RE: ATCB

FCC ID: H25VMS2000

4.)continued

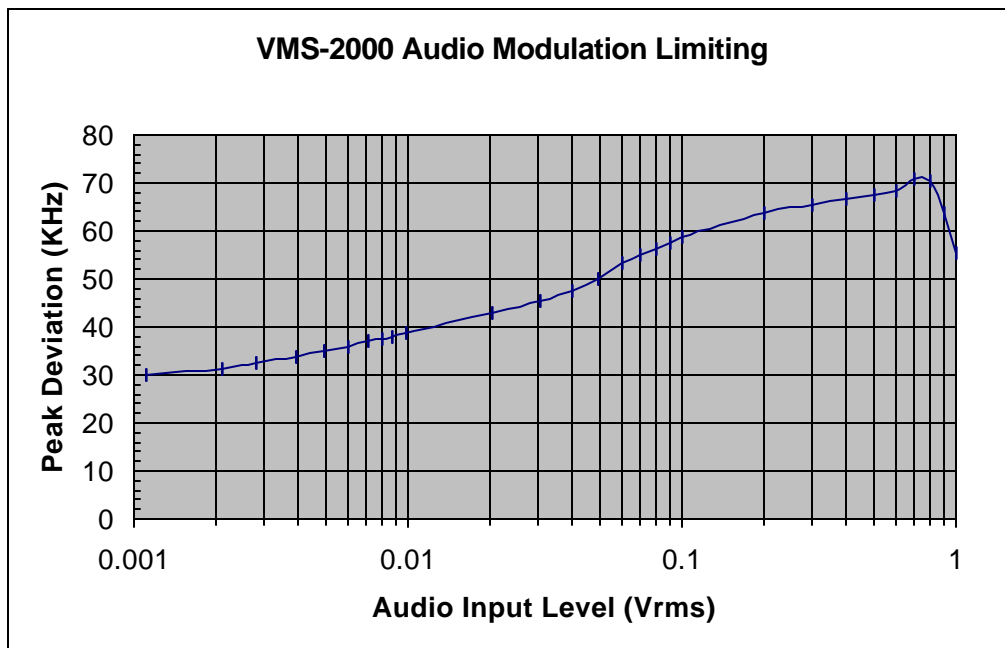
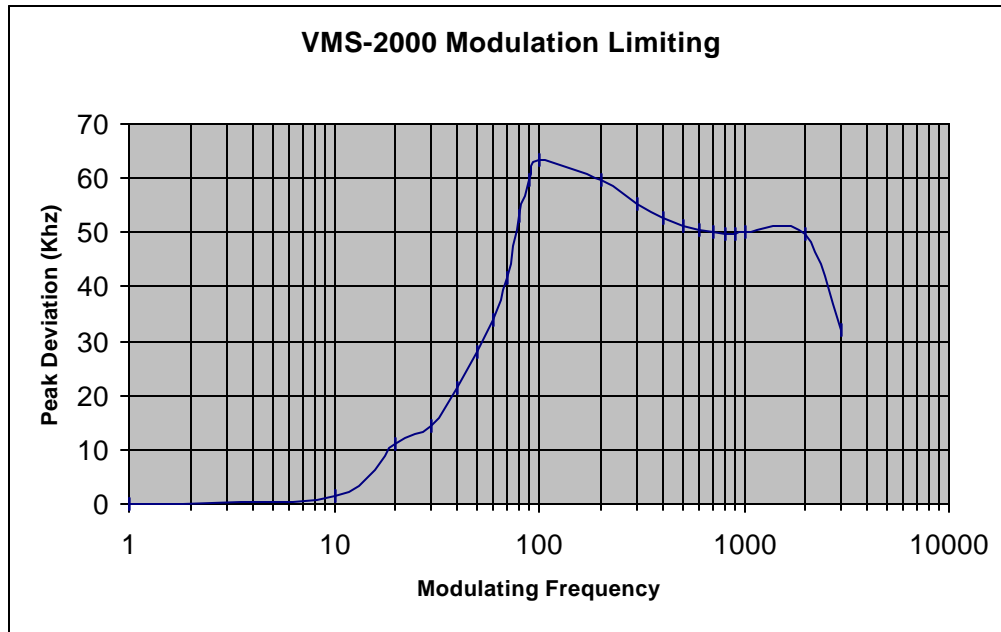
4.) We fully understand that a 1Vp-p is used for video signals. However no curves or series of curves are presented to show compliance with 2.1047(d). Ideally, a measurement using a Bessel function analysis could be presented.

Per our phone conversation on March 25th at 5:00pm the purpose of this question was a concern that higher frequencies would over deviate the carrier.

The signal modulating the main carrier consists of a standard NTSC video signal as well as up to two audio subcarriers in the range of 6.0 – 7.5 MHz.

The NTSC video signal has a 1 Vpp maximum level and a bandwidth of 4.25 MHz maximum. The video processing circuit of the transmitter consists of a pre-emphasis network that conforms to the CCIR 405 525 line curve which is the NTSC standard. It is the content of the video signal in conjunction with the pre-emphasis network that insures that the occupied bandwidth will never exceed the limit as defined by the calculated necessary bandwidth and §90.210(b). The test signal used when measuring occupied bandwidth (75% color bars from a video pattern generator) contains high frequency content at amplitudes that far exceed that which would be received from a video camera. Even under conditions of extreme brightness, a video camera is virtually incapable of generating a signal that would cause the transmitter's occupied bandwidth to exceed that measured using the 75% color bar signal. Therefore, the 75% color bar signal represents a worse case modulation condition.

By definition, the first pair of modulation sidebands due to the audio subcarriers always occur at a frequency that is offset from the main carrier less than 50% of the authorized bandwidth. The highest modulation index achieved due to the subcarriers is $M=0.1$ (for the 6.0 MHz subcarrier). This modulation index results in a maximum level for the first pair of sidebands that is nominally 26 dB below the main carrier. The level of the second pair of sidebands is nominally 58 dB below the main carrier.

The response of the video modulator signal is limited by the roll-off of the video amplifier above 5 MHz.
